Product / Process Change Notification (PCN)

PCN #: PCN_FeTEMA_20220603

Affected Series: 782115xxxxx

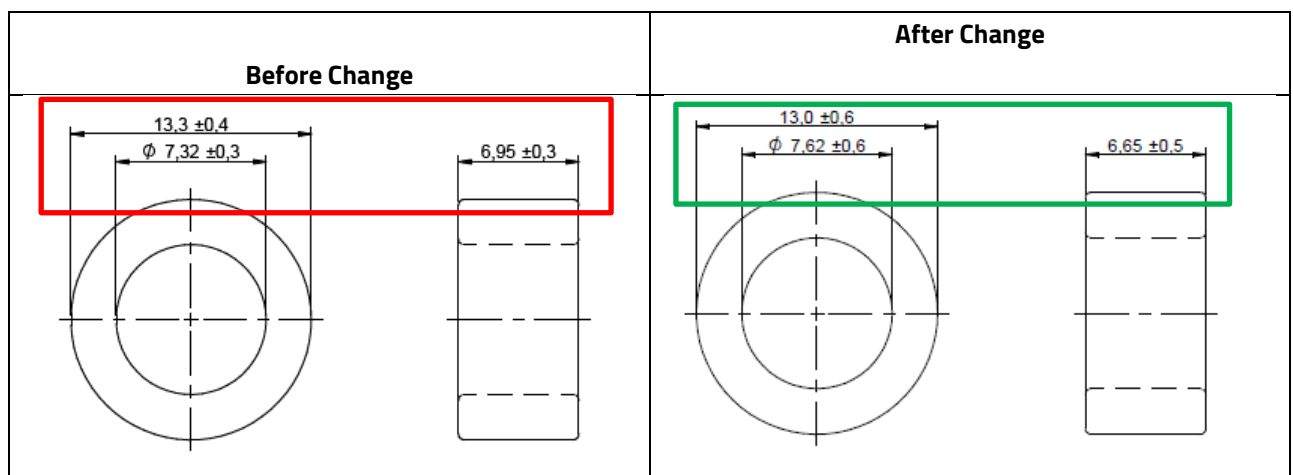
Because of a database mismatch, Würth Elektronik will correct some dimensions and tolerances in the drawing.

Example:

WE partnumber	OD	Tol	ID	Tol	H	Tol
	mm	mm	mm	mm	mm	mm
782115069064	13.3	±0.4	7.32	±0.3	6.95	±0.3
782115070080	14.6	±0.4	9.4	±0.3	8.6	±0.3
782115110070	16.6	±0.3	11.4	±0.3	7.6	±0.3
782115222150	38.6	±0.6	21.4	±0.6	14.6	±0.4

WE partnumber	OD	Tol	ID	Tol	H	Tol
	mm	mm	mm	mm	mm	mm
782115069064	13.0	±0.6	7.62	±0.6	6.65	±0.5
782115070080	14.3	±0.6	9.7	±0.6	8.3	±0.5
782115110070	16.3	±0.6	11.7	±0.6	7.3	±0.5
782115222150	38.4	±0.9	21.6	±0.9	14.4	±0.7
